Tennessee Valley Authority, 1101 Market Street, Chattanooga, TN 37402

CNL-17-082

Clinch River Nuclear Site  
NRC Docket No. 52-047

Subject: Submittal of Supplemental Information Associated with Site Safety Analysis Report Section 2.5 in Support of the Clinch River Nuclear Site Early Site Permit Application

**Figure 2.5.1-27**  
**Location A, Cross Section: A-A'**  
**Cavity Diameter: 15 ft, Embedment Depth: 90 ft**  
**Cavity Location: 30 ft Below Edge of Common Basemat, Bedding Plane,**  
**Shear Joint Interface**

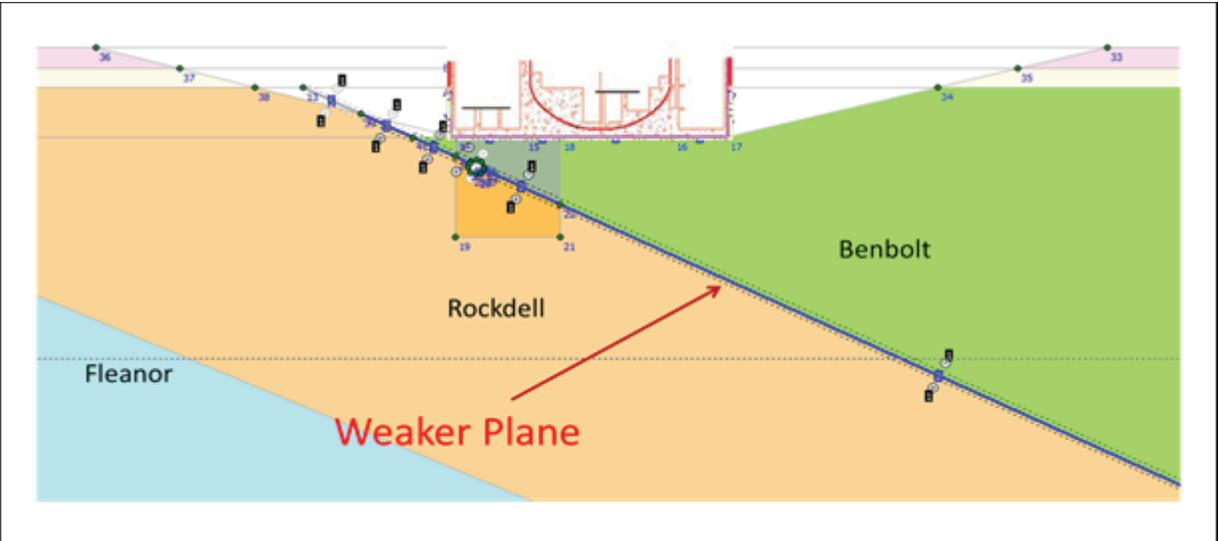
New references 2.5.4-59 and 2.5.4-60, new tables 2.5.4-33 and 2.5.4-34, and new figures 2.5.4-27 through 2.5.4-30 are being added.
